SERVICE BULLETIN

LANDING GEAR - MAIN LANDING GEAR COMPLETE - INTRODUCTION OF A NEW CAP

Aircraft affected: Airbus A350-900

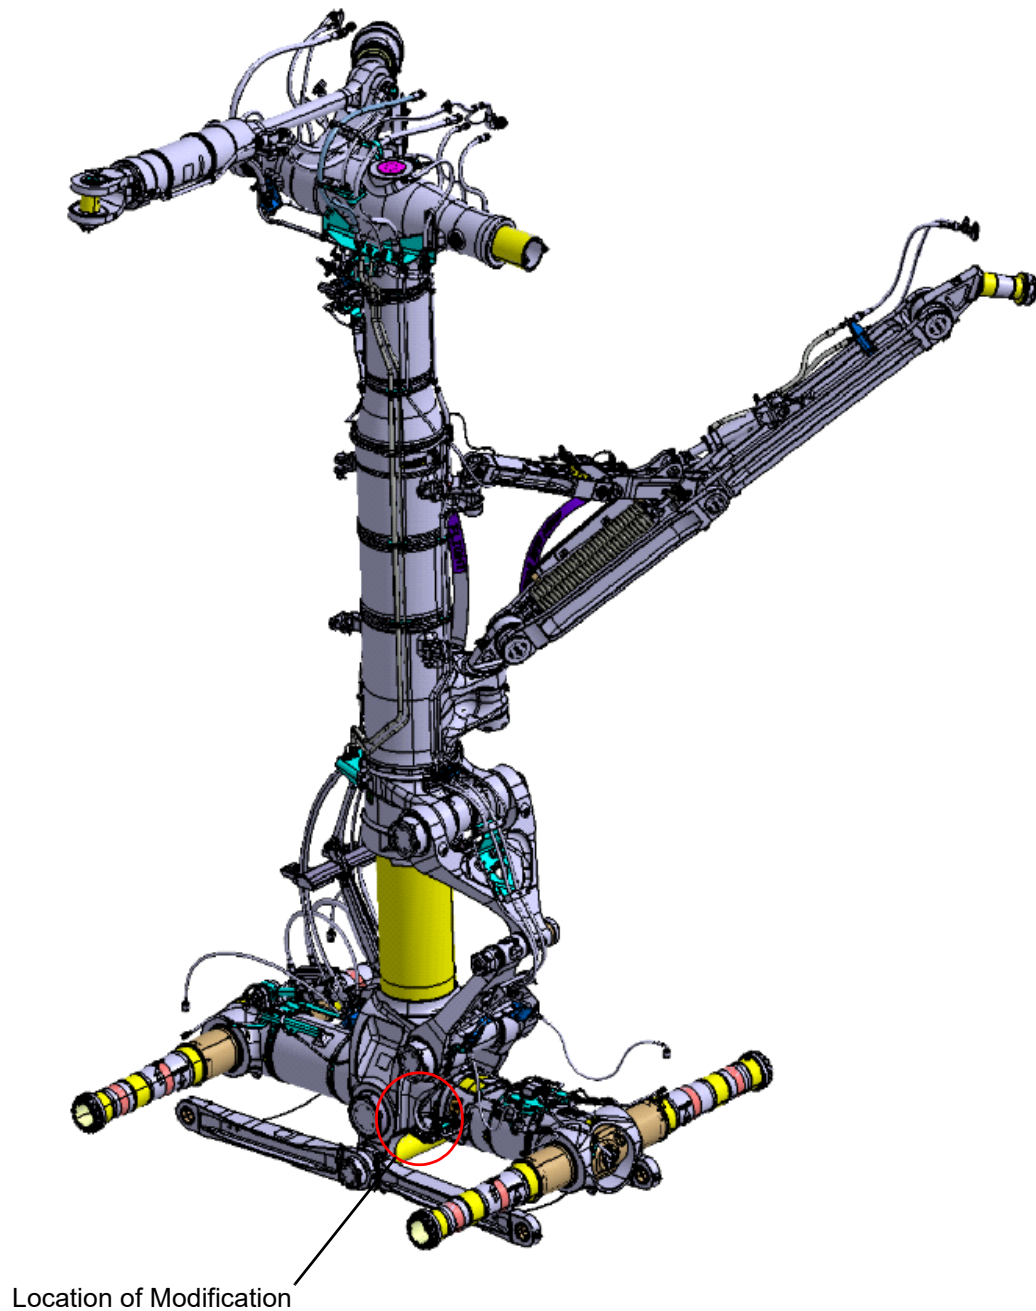
- cancel the related strike number 10 on the 10-357303 LH Series and 10-357403 RH Series shock strut dressings nameplate, refer to M-DLPS1006-5 and cancel like this 
- write the Service Bulletin number 10-355-32-29 in the applicable aircraft and landing gear records.

Figure 1

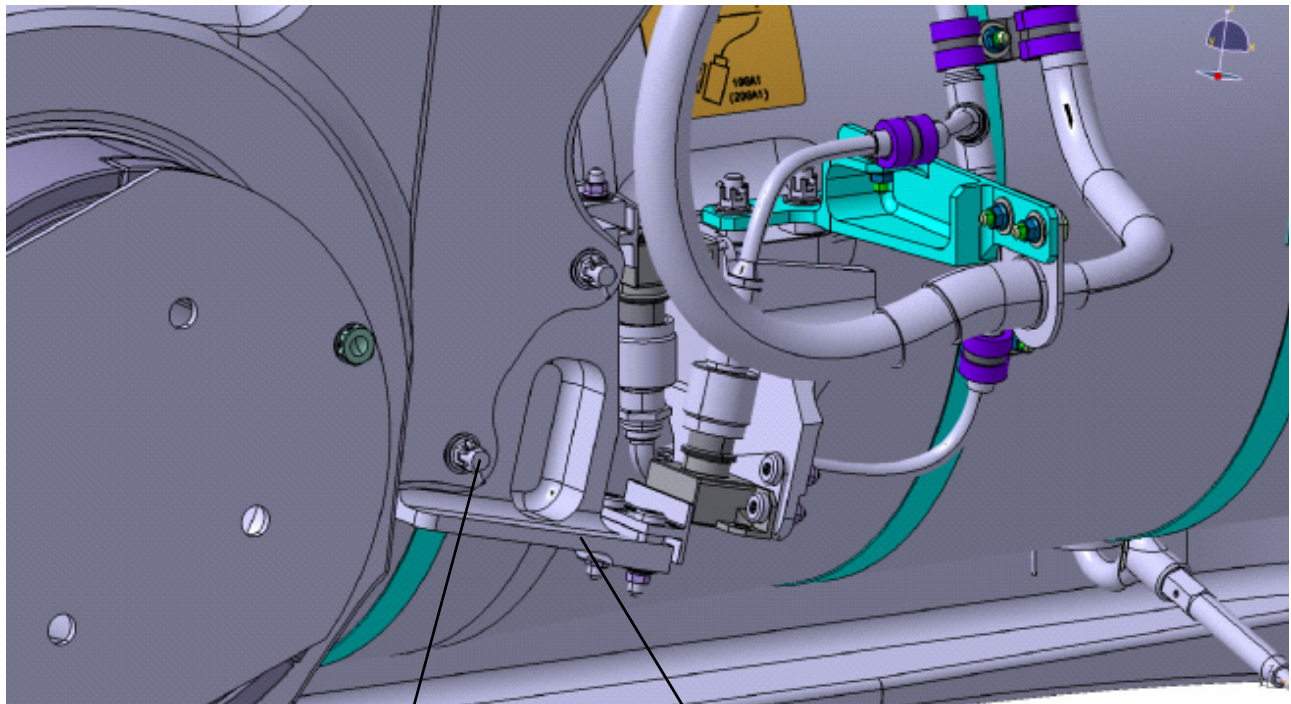
(1) A new cap is introduced in the bogie disconnect location of the 1M Strut harness to avoid the risk of chafing.

LH Main Landing Gear View from Outboard - Location of Modification

Before Modification
Figure 2

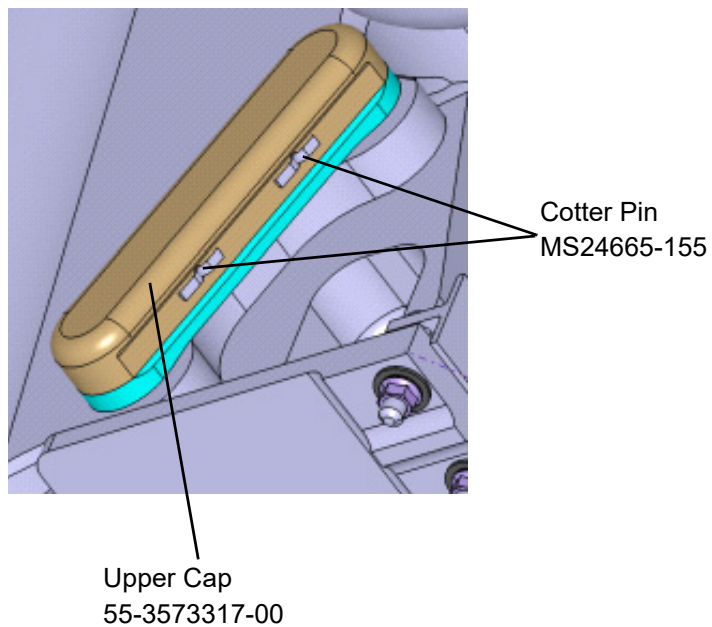
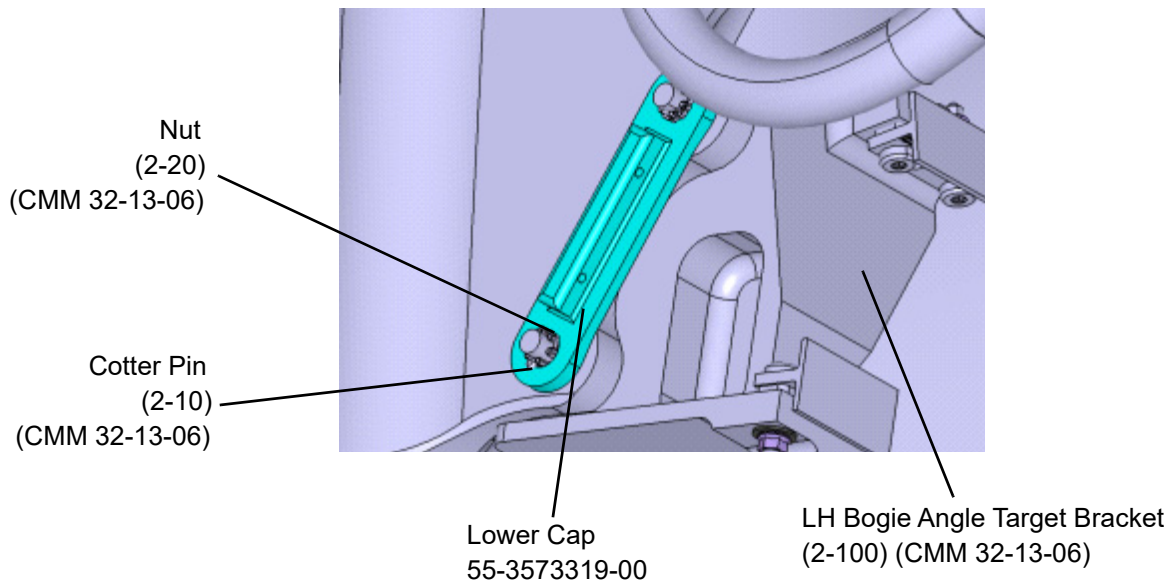
- (1) Safran Landing Systems tells operators that a new cap is introduced to prevent contact between the 1M strut harness and a bolt in the location of the sliding piston fork.
- (2) Safran Landing Systems recommend that you do this Service Bulletin on main landing gears on which:
- the strike number 10 has not been cancelled on the 10-357303 LH Series and 10-357403 RH Series shock strut dressings nameplate and looks like this 10.

Bolt (2-40)
Flat Washer (2-30)
Nut (2-20)
Cotter Pin (2-10)
(CMM 32-13-06)

LH Bogie Angle Target Bracket
(2-100) (CMM 32-13-06)

1 Install the new lower cap 55-3573319-00 on the nuts (2-20).

2 Install the cotter pins (2-10) with their heads parallel to the bolt (2-40) head. Make sure that the heads of the cotter pins are hard against castellations of the nuts (2-20). Bend the legs of the cotter pins laterally around the nut castellations to safety them: refer to PCS-7610.

4 Install the new upper cap 55-3573317-00 on the lower cap 55-3573319-00.

5 Install the new cotter pins MS24665-155 through the upper cap 55-3573317-00 and the lower cap 55-3573319-00 and safety them: refer to PCS-7610.
